Appendix 1: Asset Owners' Feedback

Thank you for the opportunity to provide comment on the referral of the proposed 57 unit residential apartment building at 11 and 13 Fleet Street, Eden Terrace (the Project) for consideration under the COVID-19 Recovery (Fast-track Consenting) Act 2020 (Covid 19 Recovery Act).

Fleet Street Apartments

Address: 11 and 13 Fleet Street, Eden Terrace

Stormwater servicing

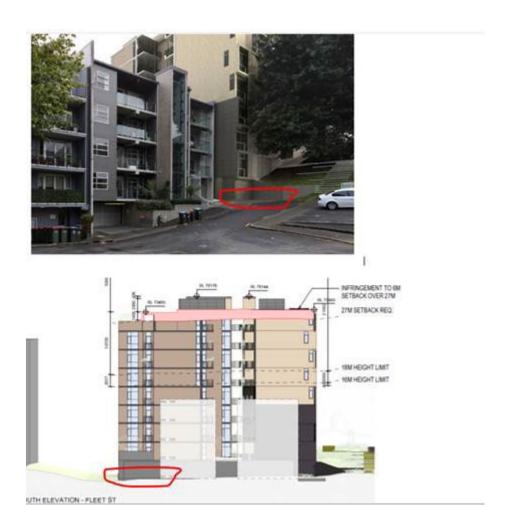
The downstream 375 mm diameter stormwater network is unlikely to have 10yr Annual Recurrence Interval (ARI) capacity. Detention of the 10 year ARI event to pre-development levels is required as a minimum.
